# **Iris Carrier Board**

Errata Document

Figure 1: Incorrectly assembled C133 highlighted

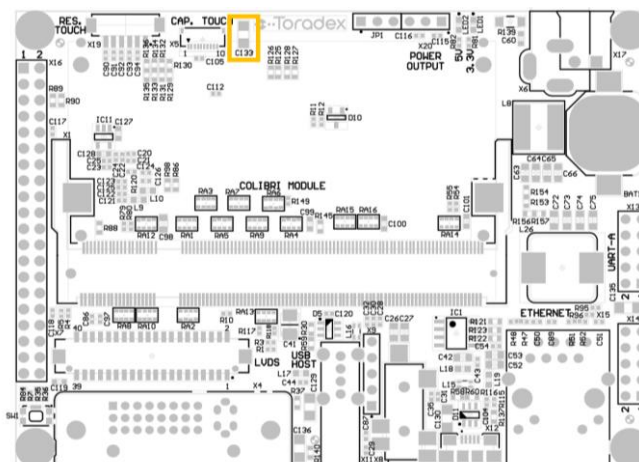
An early production lot of the Iris V2.0A is affected by an assembly issue. The assembled capacitor C133 (Figure 1) violates a keep-out zone defined for Colibri SoMs featuring an FFC connector on the bottom. These SoMs may not be appropriately inserted into the module connector of the affected carrier boards, potentially resulting in connection or reliability issues.

Removal of the capacitor C133 fully resolves the issue. The modification does not impact carrier board functionality. C133 is not assembled on later production lots of the Iris V2.0A.
